SUBJECT: REVIEW AND CONCLUSIONS REGARDING "SPECIAL REPORT ON
MONITOR WELL ANALYTICAL RESULTS," MARCH 25, 1981, FROM
OGLE PETROLEUM

BISON BASIN MINE
WELLFIELD LAYOUT
(R&D AREA)

FIGURE 1

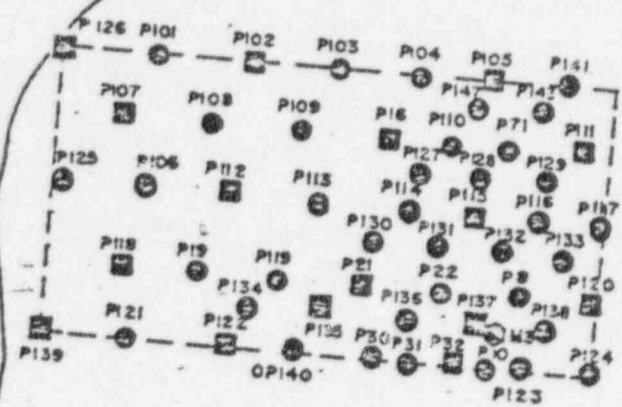
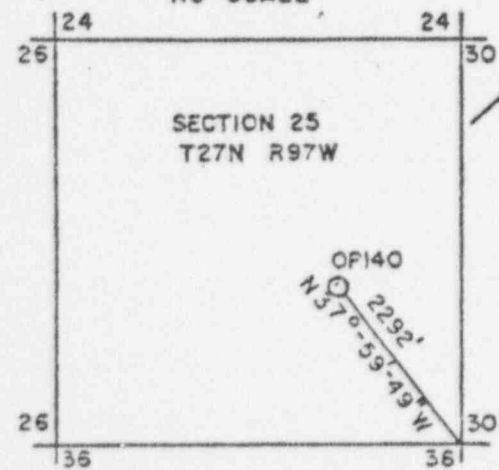
- (1) Two "minor" lateral excursions occurred at Ogle Petroleum's R&D well field in wells M-2 and M-4 (see attached Figure 1) where (a) well M-2 exceeded UCL's for Cl and $\text{CO}_3 + \text{H}_2\text{CO}_3$ by a maximum of = 15 ppm and = 118 ppm, respectively, and (b) well M-4 exceeded UCL's for Cl, $\text{CO}_3 + \text{H}_2\text{CO}_3$, and specific conductance by a maximum of = 63 ppm, = 118 ppm, and = 71 mhos/cm, respectively.
- (2) During the past month or two, well M-2 has been experiencing above-normal values for chloride and carbonate plus bicarbonate which were believed by Ogle to be caused by the normal outside sweep of the lixiviant during mining operations. An expanded outside sweep by the lixiviant was expected due to the increased injection capacity resulting from new injection wells being placed into operation in the southeast corner of the R&D well field.

The sudden increase over a two-week period in carbonate plus bicarbonate, chloride, and specific conductivity at well M-4 is believed by Ogle to have resulted from a typical horizontal excursion which was most likely caused by localized over-injection on the south side of the field well.
- (3) Control measures were implemented
 - (a) plant bleed increased,
 - (b) injection stopped and reduced and recovery increased, and
 - (c) fresh water injection into an ore zone control well 50 feet from M-2, to reverse the gradient towards the well field.
- (4) All parameters are below their UCL's for well M-4; and although Cl is still high, only $\text{CO}_3 + \text{H}_2\text{CO}_3$ exceeds its UCL at well M-2.

- (5) The results of the routine biweekly sampling of R&D monitor wells on February 4, 1981, showed that wells M-2 and M-4 exceeded their respective UCL values for at least two excursion parameters each. The seven-day confirmation sampling period verified that well M-2 was in an excursion status but indicated that well M-4 was not in an excursion status. The data to date from the sampling program indicate that the horizontal excursion at well M-2 is under control, and that technically speaking the well is no longer in excursion status.

I believe that OPI has implemented very effective clean-up and control techniques and that they are and should continue on with their monitoring and reporting to us, as they have done, if another excursion occurs.

FIGURE 1

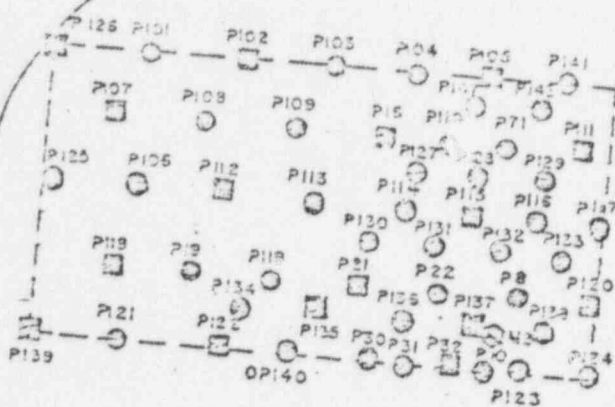
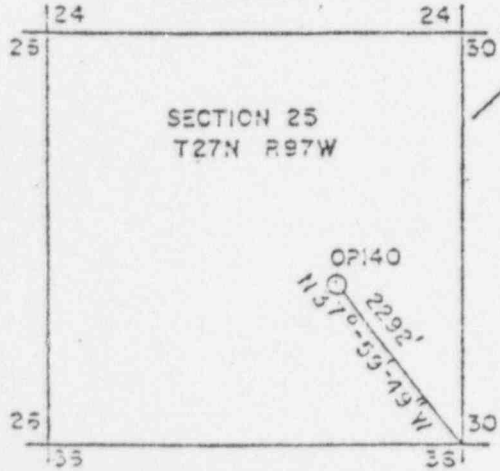
- (1.) Two "minor" lateral excursions occurred at Ogle Petroleum's R & D wellfield in wells M2 and M4 (see attached Figure 1) where (a) well M2 exceeded UCL's for Cl and $\text{CO}_3 + \text{H}_2\text{CO}_3$ by a maximum of $\approx 15 \text{ ppm}$ and $\approx 115 \text{ ppm}$ respectively, and (b) well M4 exceeded UCL's for Cl, $\text{CO}_3 + \text{H}_2\text{CO}_3$, and Specific Conductance by a maximum of $\approx 163 \text{ ppm}$, $\approx 118 \text{ ppm}$, and $\approx 71 \text{ mhos/cm}$, respectively.

During the past month or two, well M 2 has been experiencing above-normal values for chloride and carbonate plus bicarbonate which were believed to be caused by the normal outside sweep of the lixiviant during mining operations. An expanded outside sweep of the lixiviant was expected due to the increased injection capacity resulting from new injection wells being placed into operation in the southeast corner of the R & D wellfield.

The sudden increase over a two-week period in carbonate plus bicarbonate, chloride, and specific conductivity at well M 4 is believed to have resulted from a typical horizontal excursion which was most likely caused by localized over-injection on the south side of the wellfield.

- (3) After control measures had been implemented
 - (a) plant UCL increased.
 - (b) injection stopped and allowed and recovery increased and
 - (c) fresh water injection into an onshore control well 50 ft from M2, to reverse the gradient towards the well field,
- (4) All parameters are below their UCLs for well M4, and although Cl is still high, only $\text{CO}_2 + \text{H}_2\text{CO}_3$ exceeds its UCL at well M2.

(5) The results of the routine biweekly sampling of R & D monitor wells on February 4, 1981 showed that wells M 2 and M 4 exceeded their respective UCL values for at least two excursion parameters each. The seven-day confirmation sampling period verified that well M 2 was in an excursion status but indicated that well M 4 was not in an excursion status. The data to date from the sampling program indicate that the horizontal excursion at well M 2 is under control, and that technically speaking the well is no longer in excursion status.

- (1) I believe that OPI has implemented very effective clean-up and control techniques and that they are and should continue on with their monitoring and reporting to us, as they have done, if another excursion occurs.
